MANUAL CHANGES

Model Number: 141T
 Date Printed: June 1976
 Part Number: 00141-90914

Figure 1. Component Identification, Power Supply A2

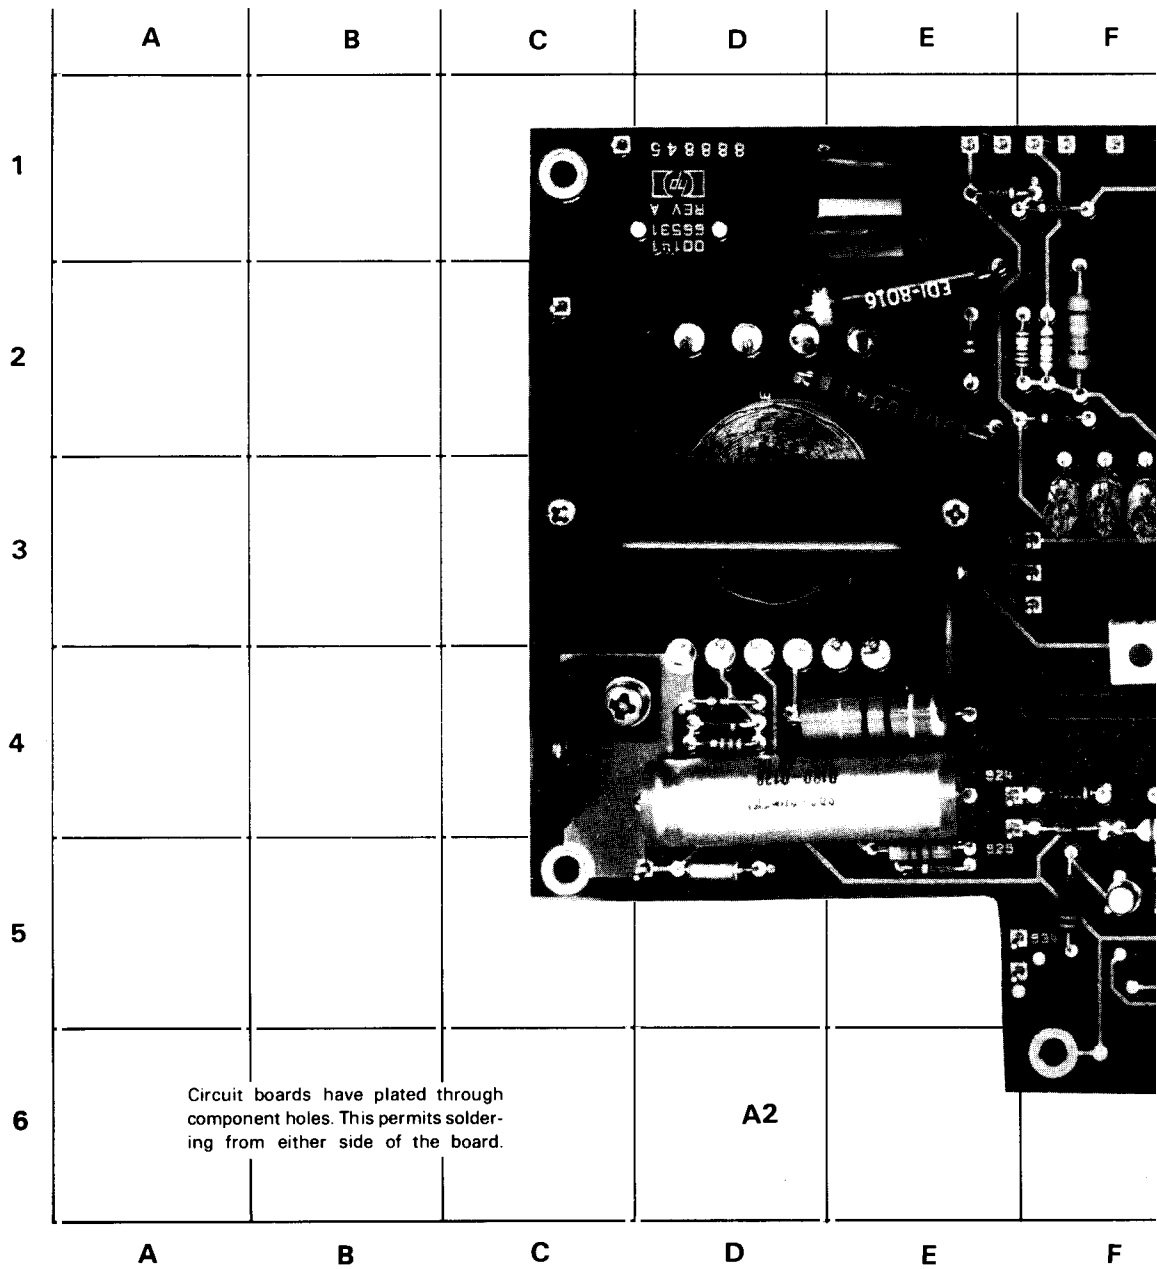
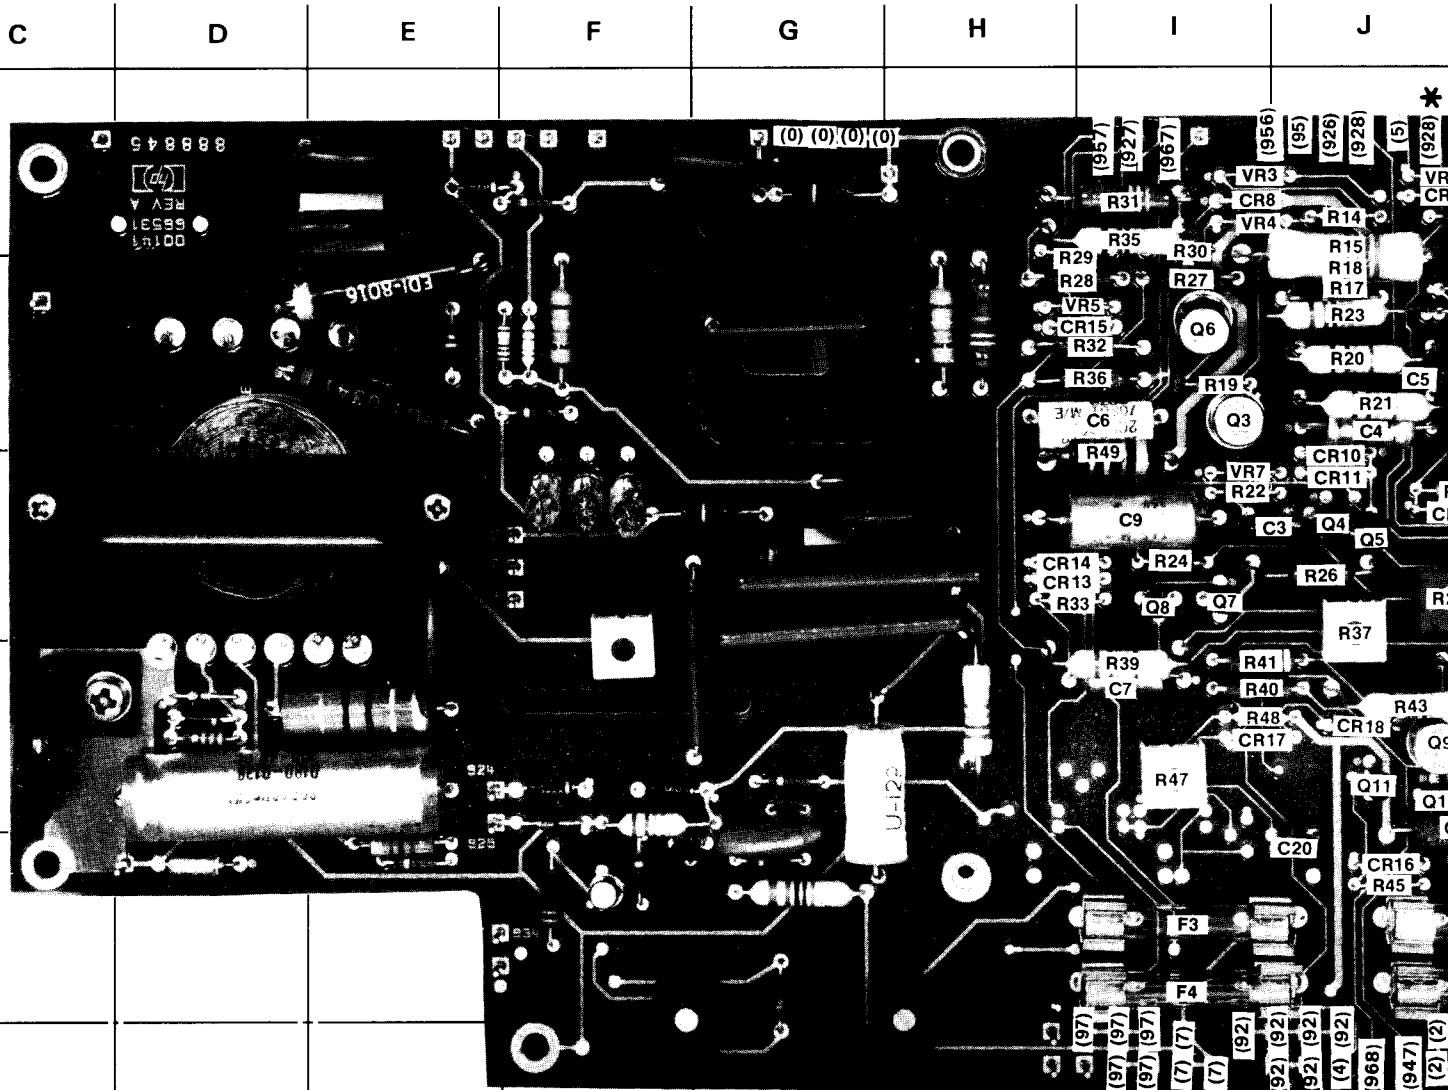
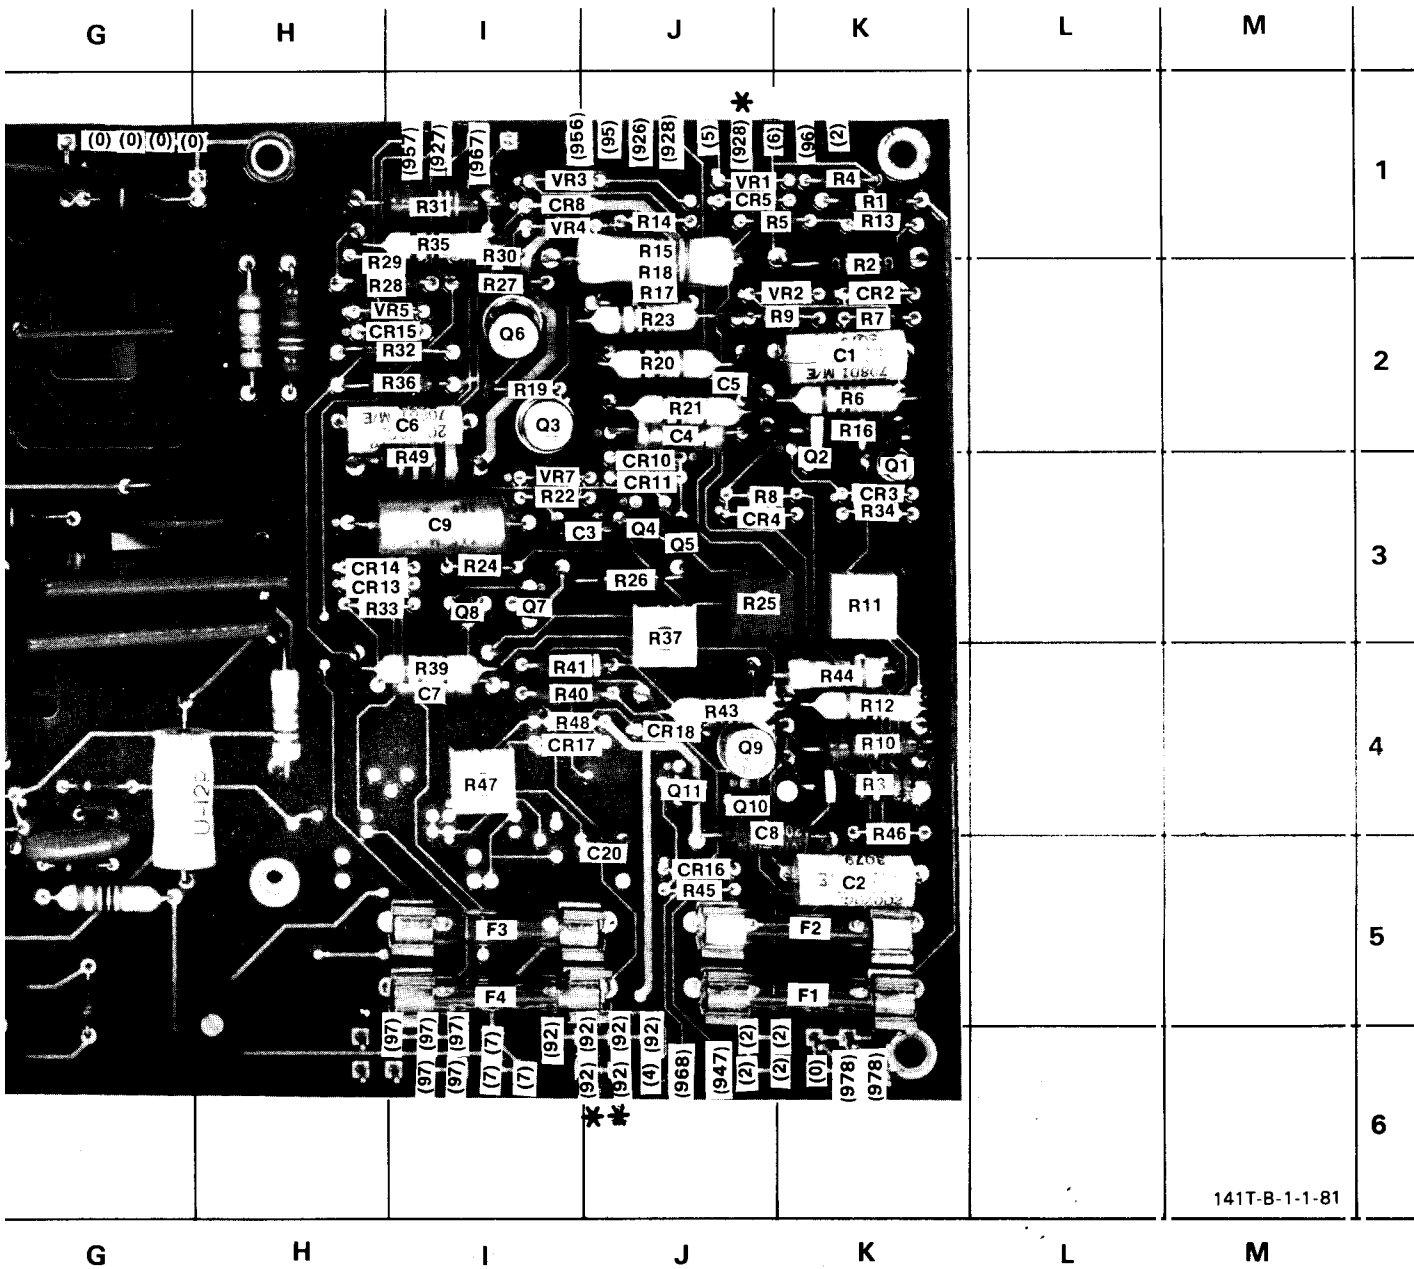
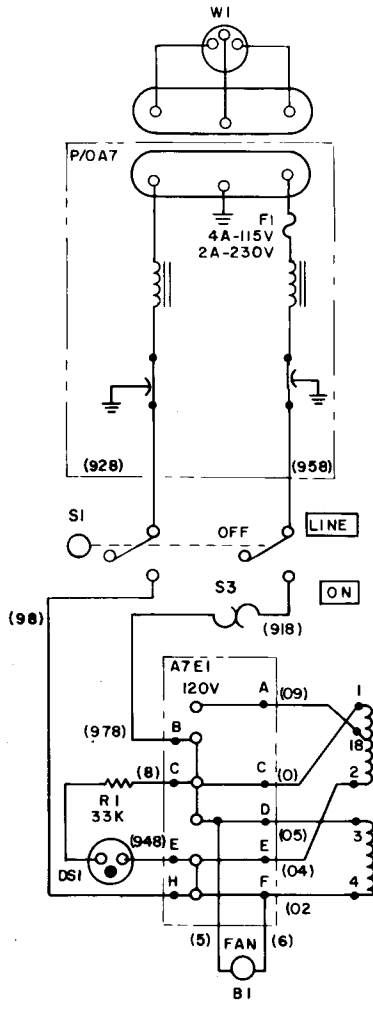
Refer to Figure 1 of this document for location of power supply, intensity, and geometry adjustments.

Figure 8-8. Component Identification, Power Supply A2 (page 8-14),

Replace with Figure 1 of this document.
